THE MARYLAND-NATIONAL CAPITAL PARK AND PLANNING COMMISSION

DATE: May 29, 2002
TO: Montgomery County Planning Board
VIA: Joe Davis, Chief *JRD*
Development Review Division
FROM: Larry Ponsford AIA AICP, Supervisor *LRP*
Development Review Division
(301) 495-4576
PROJECT NAME: **Fairfield at Germantown**
CASE#: 9-02002
REVIEW TYPE: Project Plan
ZONE: RMX-2, R-200
APPLYING FOR: 610 garden apartments, 250,000 GSF office/retail on 62.4 acres
LOCATION: East of CSX tracks between MD #118 and Father Hurley Blvd.
MASTER PLAN: Germantown
REVIEW BASIS: Sec. 59-C-10 and 59-D-2 of Montgomery County Code
APPLICANT: F.F. Development, L.P.
FILING DATE: December 27, 2001
HEARING DATE: June 13, 2002

SUBJECT: Project Plan No. 9-02002
Fairfield at Germantown

**FAIRFIELD AT
GERMANTOWN**
MONTGOMERY COUNTY, MARYLAND

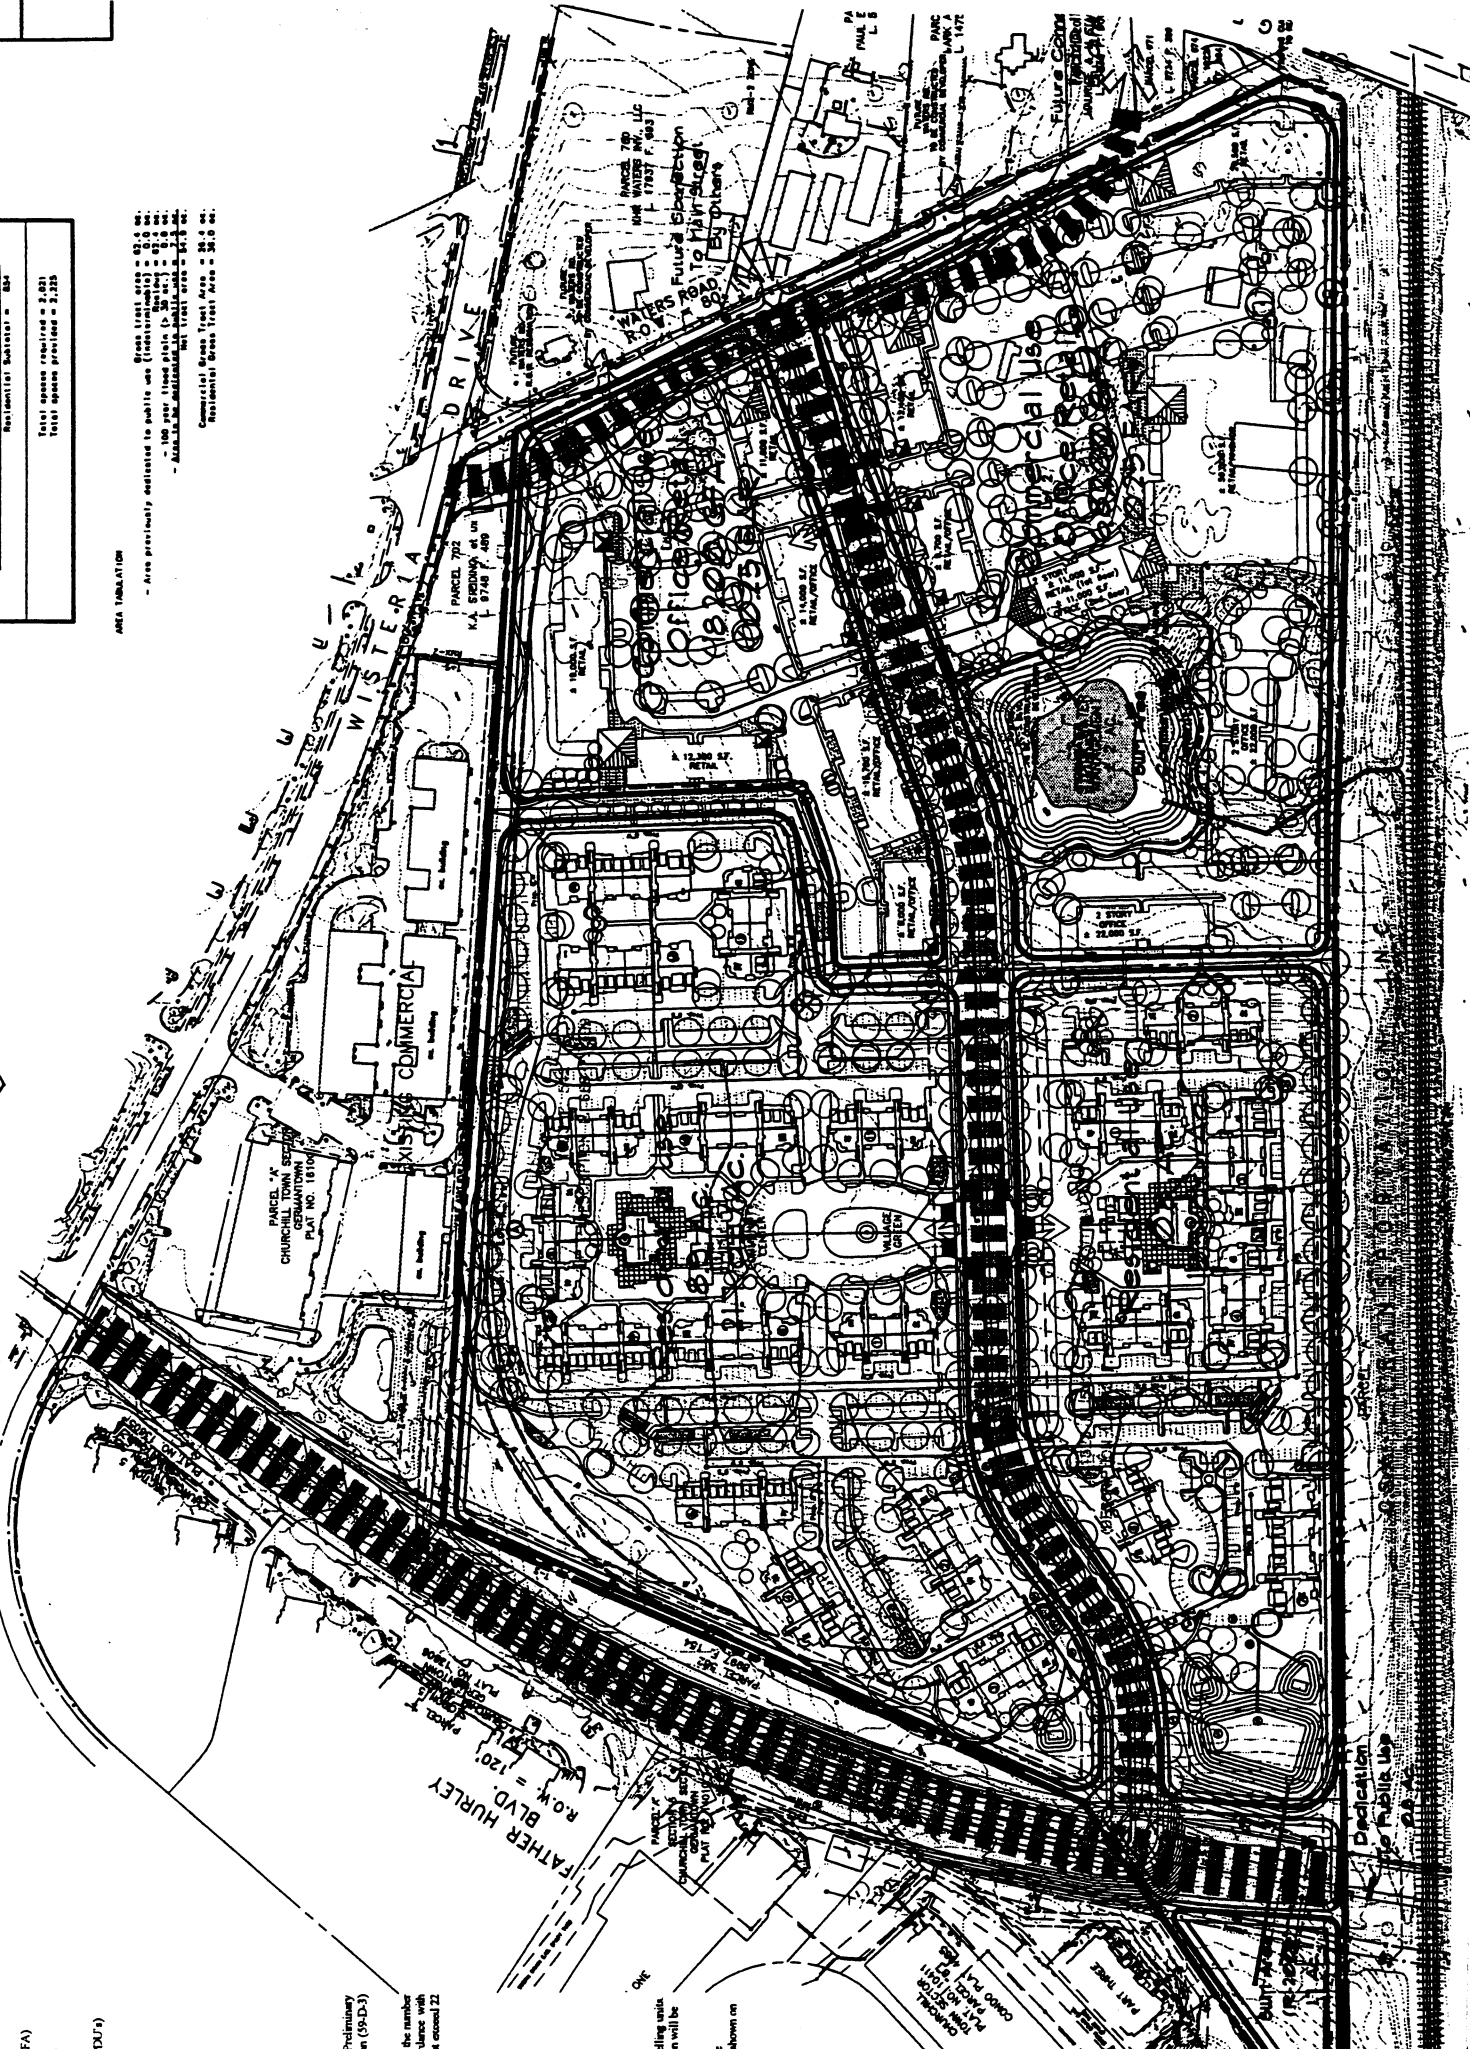
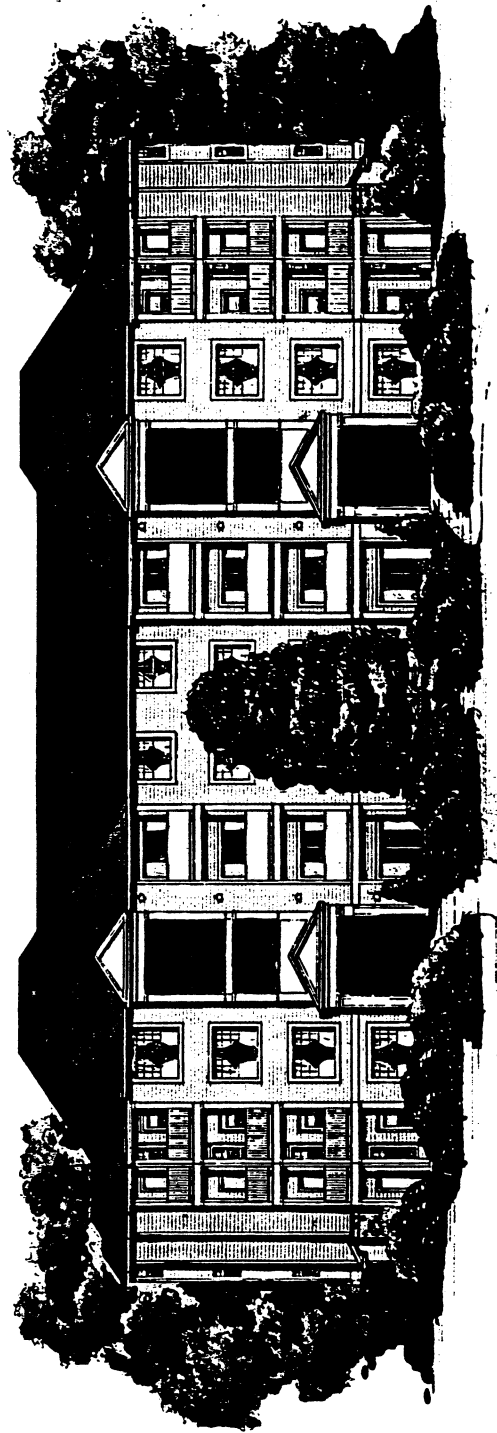
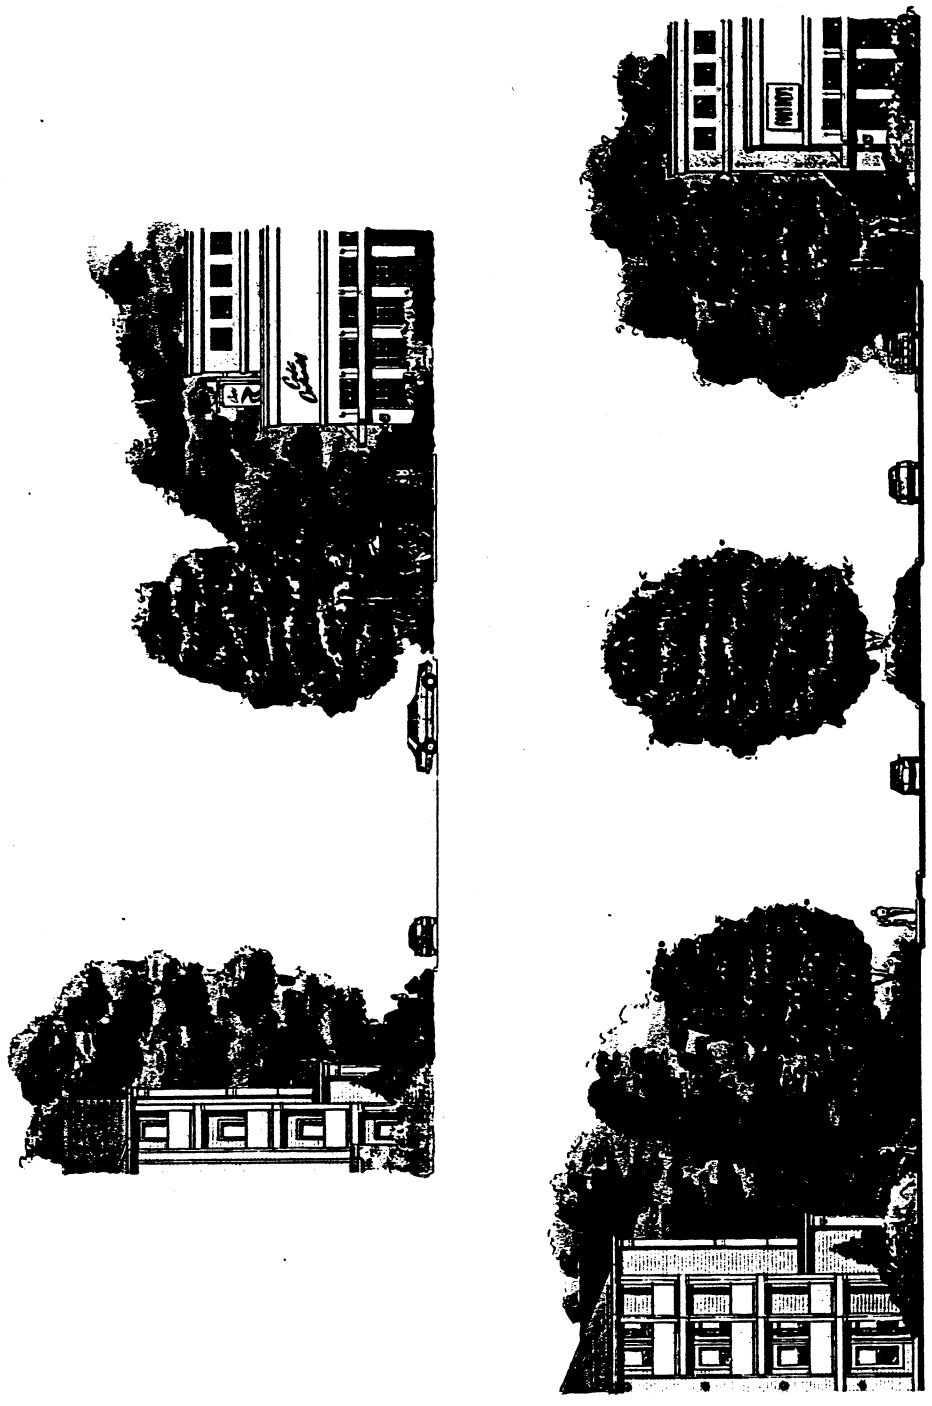
1. The commercial portion of this Project Plan is approved in concept only; the future commercial applicant must resubmit a complete Project Plan application for the commercial portion to the Planning Board for approval of the design, facilities and amenities later.

4. Construction of two lanes of Father Hurley Boulevard from Wisteria SW to the site entrance, plus the full cross section of Father Hurley from Wisteria SW for a distance of approximately 600 feet, with final scope subject to pending minor realignment of Father Hurley by MCDPWT, to include a temporary transition from these six lanes to the two beyond. Final details are to be resolved as part of the Site Plan Review submission for Fairfield.

5. For Site Plan Review, conduct a noise analysis to determine the 65-db noise contour from the tracks and Father Hurley and to propose appropriate mitigation

6. Expanded NRI must be approved prior to submission of site plan. Tree #48 on NRI, a 55-inch Southern Red Oak in good condition, should be saved if possible.

7. All trails to be located outside environmental buffers

Figure 13
 Total Future Lane Use and Traffic Control
 for Phase 2 (610 Units + 210,000 S.F. Retail,
 and 40,000 S.F. Office)

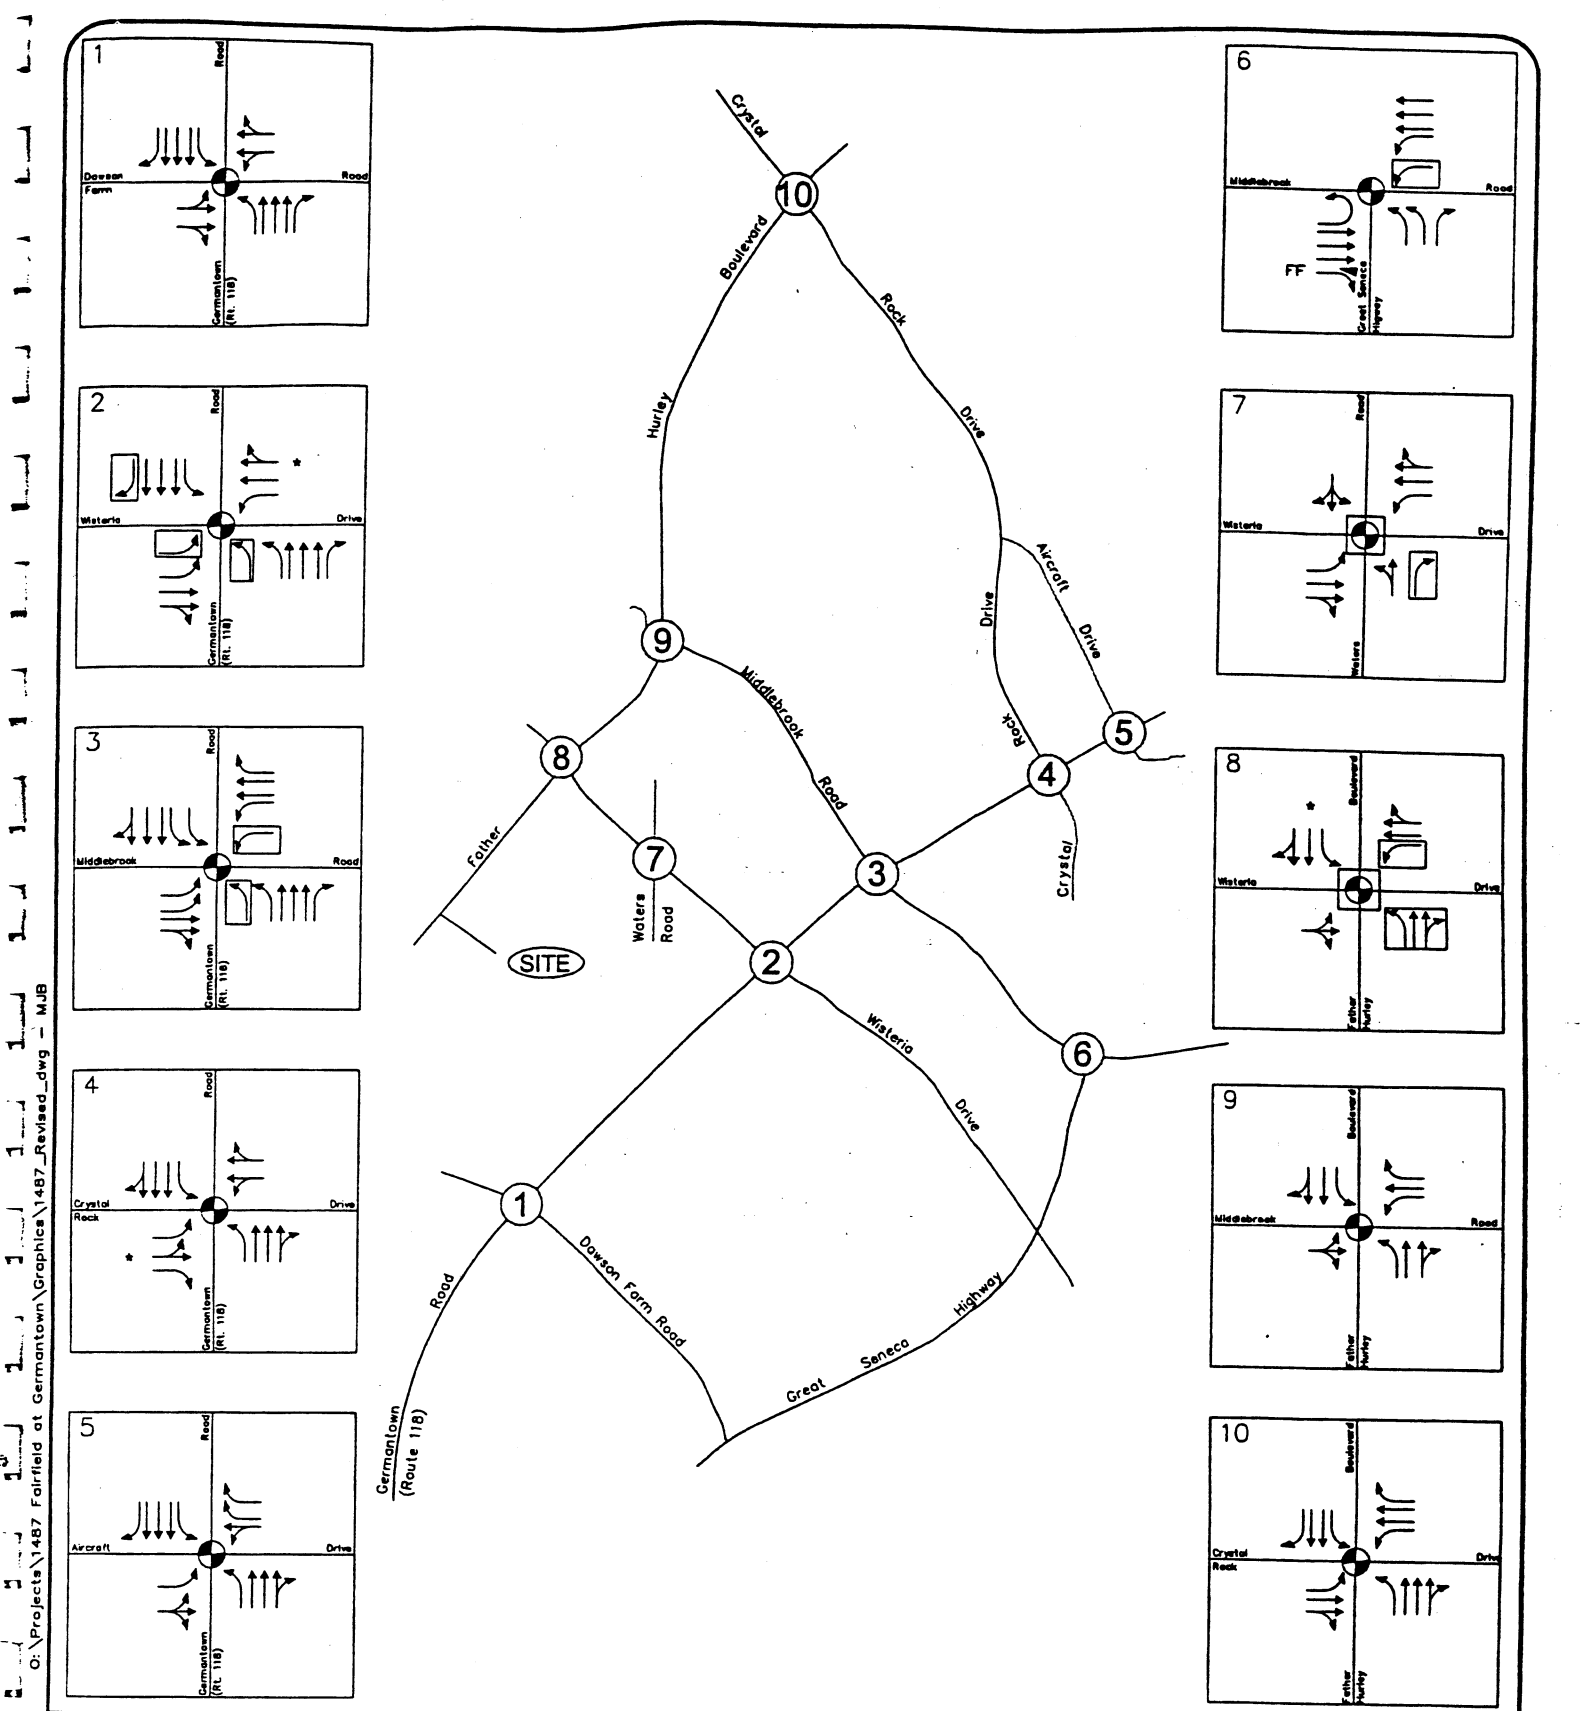
1. Total development under this project plan application is limited to the following uses and density:
 - 610 garden apartments
 - 210,000 square feet of retail space
 - 40,000 square feet of general office space
2. To satisfy Local Area Transportation Review:

- a. The applicant shall construct a separate southbound right-turn lane, a second northbound left-turn lane, a second eastbound left-turn lane, and restripe the separate westbound right-turn lane on Wisteria Drive as a shared through and right-turn lane (Phase 1) at the MD 118/Wistria Drive intersection.

- b. The applicant shall construct a second westbound left-turn lane (Phase 1), a second northbound left-turn lane, and modify the traffic signal to eliminate eastbound-westbound split phasing at the MD 118/Middlebrook Road intersection (Phase 1). Also, the applicant shall design and construct the removal of the channelized (free flow) located in the southeast quadrant of this intersection, provided monies required to be escrowed pursuant to Site Plan No. 8-84011A (Northlake Commerce Center –Condition 2) and Site Plan No. 8-98042 (Germantown Town Center Phase I – Condition 10) are available for the improvement and Preliminary Plan No. 1-99020 (north Germantown - Condition 1) participate in the improvement as required by its approval. (Phase 1)

- c. The applicant shall restripe the eastbound Crystal Rock Drive approach to provide a separate right-turn lane, a separate through and left-turn lane, and a separate left-turn lane at the MD 118/Crystal Rock Drive intersection. (Phase 1)

- d. The applicant shall construct a second westbound left-turn lane at the (Great Seneca Highway (MD 119)/Middlebrook Road intersection. (Phase 2)
- e. The applicant shall construct a separate northbound right-turn lane, restripe and designate existing Wisteria Center Lane for separate left-turn lanes, and install a new traffic signal if warrants and spacing criteria are met at the Wisteria Drive/Waters Road intersection. (Phase 2)

- f. The applicant shall construct a westbound left-turn lane on Wisteria Drive, a separate left and through lanes on Father Hurley Boulevard (FHB), and install a new traffic signal if warranted at the Father Hurley Boulevard intersection. (Phase 1)

- g. The applicant shall construct two lanes of Father Hurley Boulevard from Wisteria Drive SW to the site entrance, plus the full cross section of Father Hurley Boulevard from Wisteria Drive SW for a distance of approximately 600 feet, with final scope subject to pending minor realignment of father Hurley boulevard by the Department of Public Works and Transportation (DPWT), to include a temporary transition from these six lanes to the two beyond. Final details are to be resolved as part of the Site Plan Review submission for Fairfield.
